■ **COTTAGES AT COLLEGE ACRES [TRC Plan Review #3]**

TECHNICAL STANDARDS – [City/ADA standards]:

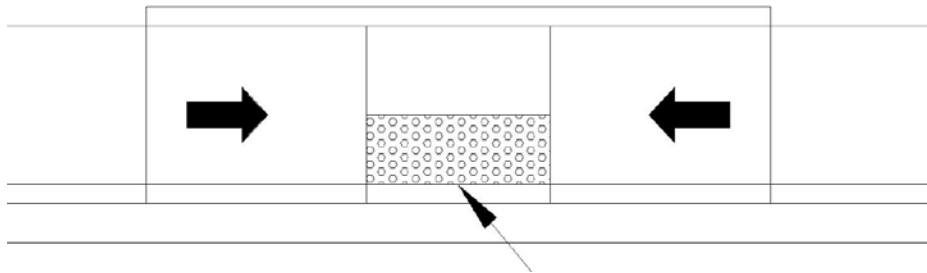
1. Pavement markings are missing from an accessible aisle in front of building 38.
2. Detectable warning domes shown at the sidewalk connecting a commercial type driveways, is not required since the pedestrian right-of-way and sidewalk continues across the driveway.
3. Detectable warning domes installation is required before entering drive aisle/pavement surface. This is applicable to all the accessible aisles leading to sidewalk without/without ramps. Below image is for reference only.
